BARC (T)/NRB/INRPC/PD/2026/863

**Minutes of Pre-Bid meeting (MOM)**

Ref. NIT:- BARC(T)/NRB/INRPC/PD/MPT- 556/2026/754 Dt: 28/04/2026

Name of work:- Procurement, Supply, Delivery, Fabrication, Installation, Erection, Testing and Commissioning of Ventilation system in Block-108A, 108B & 108D at INRPC Site, BARC, Tarapur.

## Annexure -1

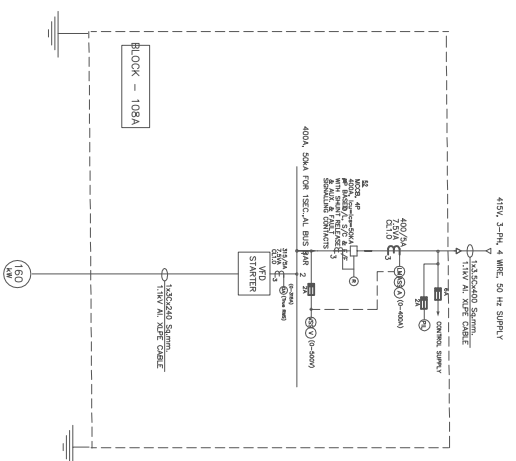
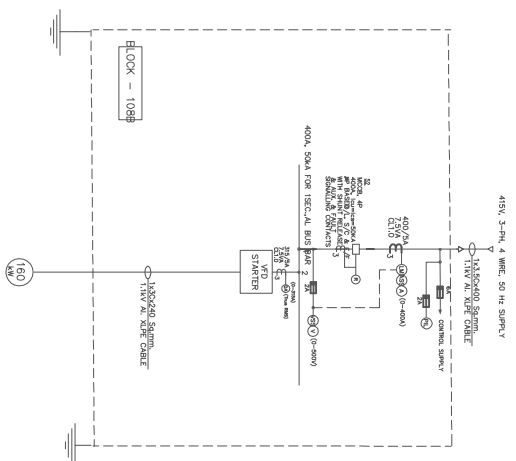
13	Item no. 1.01, 1.02, 1.03 of Price Schedule: Centrifugal type Ventilation Fans It is understood that the fans along with motor and panel shall be supplied by you as a Free issue material. However, the bidder shall be responsible for installation of fans as well as for supply of consumables like grease, bearings, flexible connections, mortar and V-belts. Kindly confirm. We request you to keep the consumables in your scope, since it is not possible to identify and procure matching bearings and V-belts for the fans already supplied in the past.	Supply of consumables as per BOQ is in the scope of contractor.
14	Item no. 17 of Price Schedule: MS Filter retainer frame for HDPE filter The BOQ specifies 5 x 3 module while Pg no. 43 of technical specifications of Block 108D specifies 4 x 3 module. Kindly clarify.	Item No: 17:- MS Filter retainer frame has module size of (4 x 3).
15	Item no. 36 of Price Schedule: Emergency Spare Motor control centres It is understood that there are only 2 nos. Motor control centres in our scope comprising 1 no. Incoming MCCB and 1 no. 160 KW VFD starter each. However, there is no SLD available in the Tender documents as mentioned in the Price schedule. Kindly provide the SLD for our better understanding.	The details are given in Annexure -1 attached.

VFD panel shall be of rating 90 kW ( 1 No ) and 160 kW ( 1 No ) against 2 Nos of 160 kW as per the BOQ

### **For 90 kW VFD panel ( For Block 108 D)**

1. Supply and laying of outgoing cable along with VFD is in the scope of contractor and size and length of the cable shall be of **"1 run of 3C x 120 Sq. mm, Type: A2XWY"** and **" 50 metres "**
2. Successful bidder shall submit GA, Power and Control wiring diagram as per the **attached SLD** for approval.

### **For 160 kW VFD panel ( For Block 108A and 108B )**

1. Supply and laying of outgoing cable along with VFD is in the scope of contractor and **Size and Length** of the outgoing cable shall be of **" 2 runs of 3C x 300 Sq.mm, Type: A2XWY "** and **"150 metres"**.
2. Successful bidder shall submit GA, Power and Control wiring diagram as per the **attached SLD** for approval.
3. The scope of shifting of the VFD panels and associated power cables after testing of all the motors installed in the block 108A to block 108B or vice versa is in the scope of contractor.
